Item Name: Crosstube Fwd

DART AEROSPACE LTD		Work Order:	83081
Description: Crosstube High Fwd (205/212/412)		Part Number:	D212-664-101
Inspection Dwg: D212-664-141 Rev: D		Page 1 of 1

DRAWING NO. D212-664-141	TITLE XTUBE ASSY (205/212/412 HI FWD)	REV. D	DART AEROSPACE LTD ENGINEERING ORDER		D.E.O. NO. D212-664-141-D-1	SHEET NO. SHEET 1 OF 2	SCALE NTS
DRAWN	CHECKED	MFG. APPR.	APPROVED	DE APPR.			
DATE 11.04.07	DATE 11.04.11	DATE 11.04.12	DATE 11/04/12	DATE 11.04.12

DRAWING NO. D212-664-141	TITLE CROSSTUBE ASS'Y (205 HI FWD)	REV. D	DART AEROSPACE LTD ENGINEERING ORDER		D.E.O. NO. D212-664-141-D-2	SHEET NO. SHEET 1 OF 1	SCALE NTS
DRAWN <i>IP</i>	CHECKED <i>ASS</i>	MFG. APPR. <i>AS</i>	APPROVED <i>MD</i>	DE APPR. <i>TH</i>			
DATE 11.07.15	DATE 11.07.20	DATE 11.07.21	DATE 11/07/21	DATE 11.07.21

**D212-664-141/-141B
ASSEMBLY DETAIL**

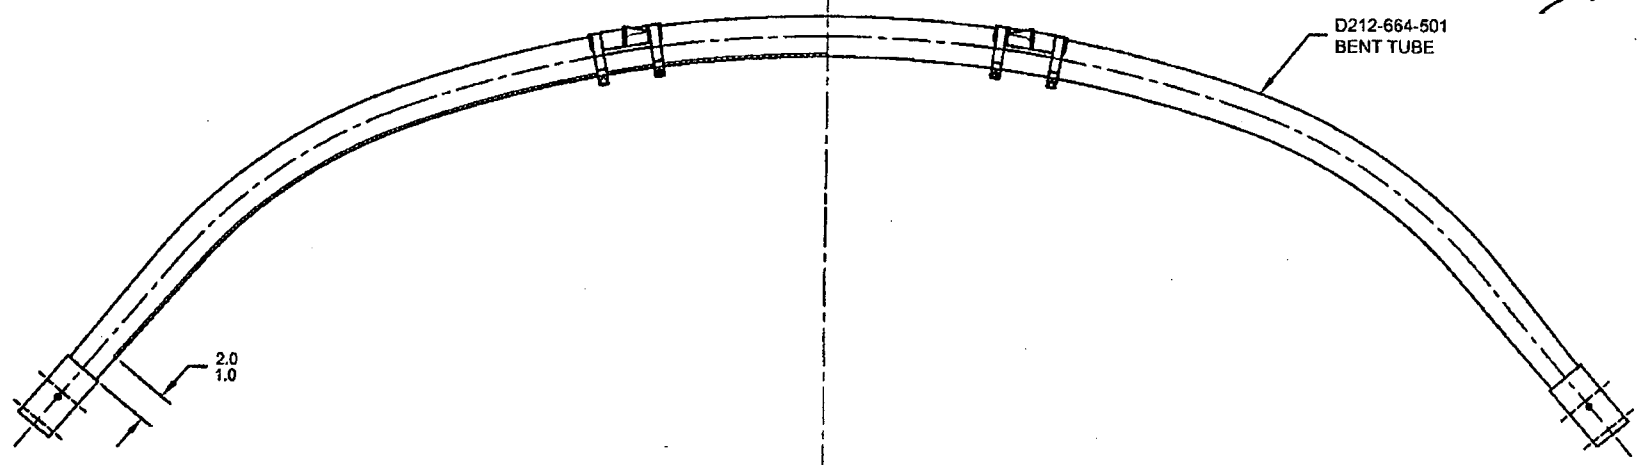
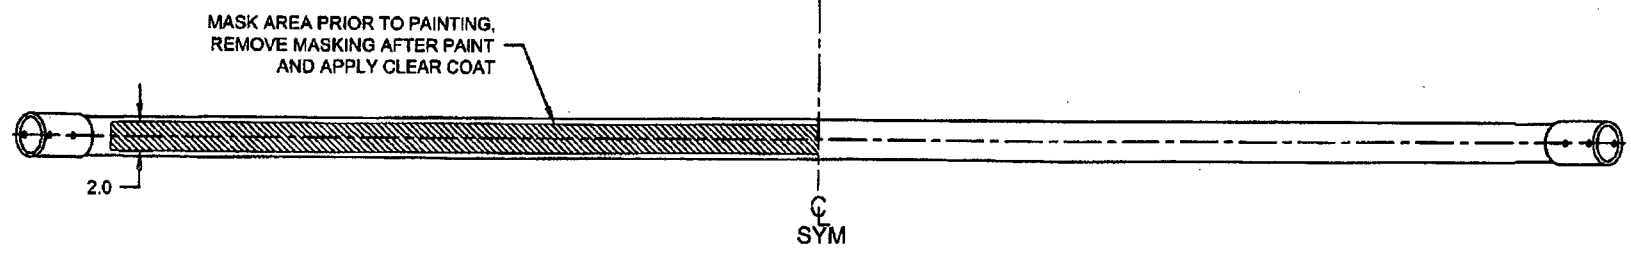
PURPOSE:

ADD AN INSPECTION WINDOW TO UNDERSIDE OF CROSSTUBE.

NOTES 2 OF SHEET 1 IS AMENDED AS FOLLOWS:

IS:

- 2) FINISH: CHEMICAL CONVERSION COAT PER DART QSI 005 4.1
PRIME INSIDE AND OUTSIDE PER DART QSI 005 4.2
MASK UNDERSIDE OF CROSSTUBE AS SHOWN (HATCHED AREA) AND
PAINT OUTSIDE PER DART QSI 005 4.2
REMOVE MASKING AND APPLY CLEAR COAT

WAS:

- 2) FINISH: CHEMICAL CONVERSION COAT PER DART QSI 005 4.1
PRIME INSIDE AND OUTSIDE PER DART QSI 005 4.2
PAINT OUTSIDE PER DART QSI 005 4.2
